Attention to ER
Tank Top to suit
Bauer Wash
Gear.

T.S.S. Port Brisbane.

Report No. 86078.

TANK TOP IN WAY OF BAUER WACH GEAR

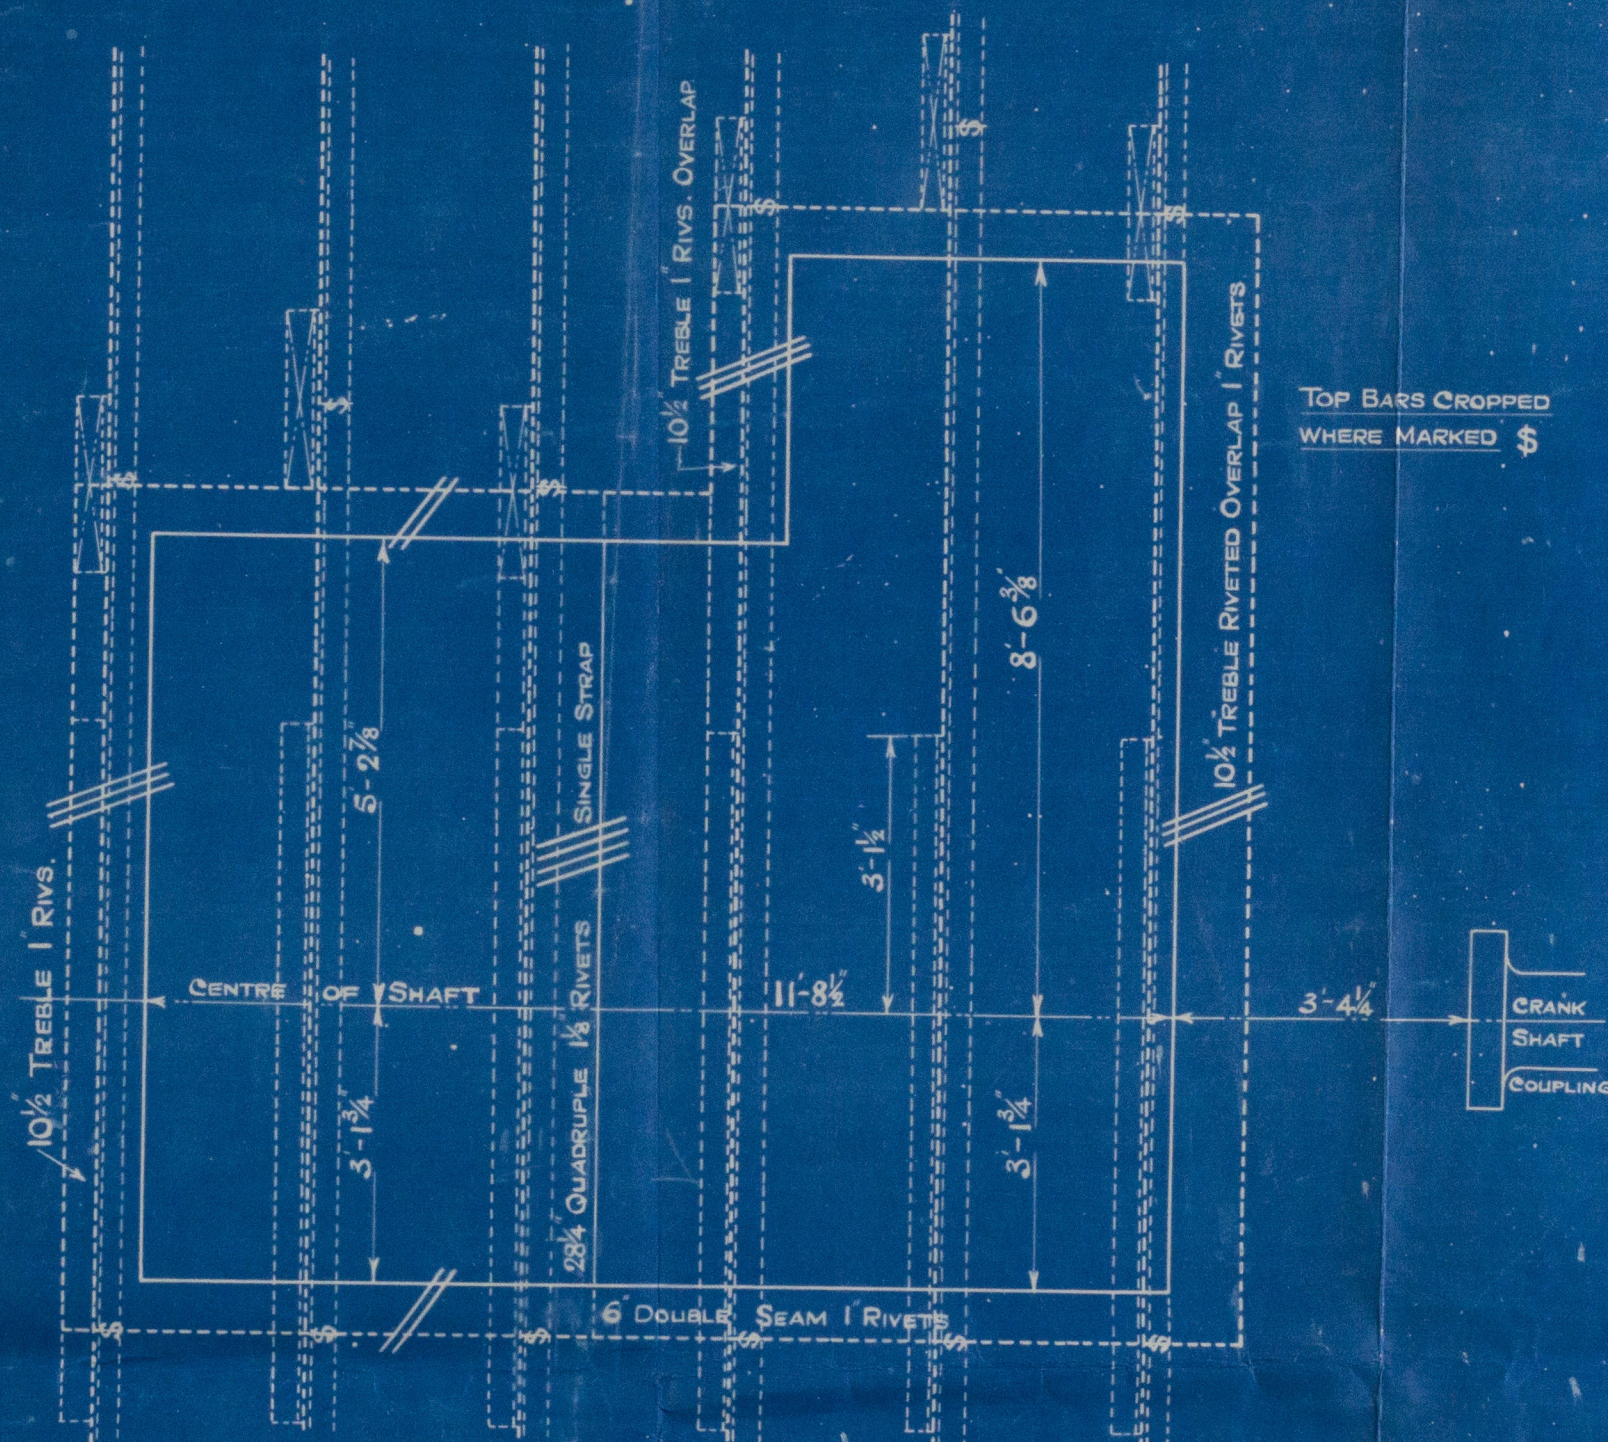
Alterations carried out
to tank top in connection
with fitting of low pressure turbine
on

^{level of}
1" NEW TANK TOP PLATING FITTED BENEATH EXISTING TANK TOP PLATING.
FLOORS IN WAY CUT DOWN TO SUIT & NEW FLOOR REVERSE BARS FITTED.

new floor to be
fitted, joggled to take new
1" tank top plate
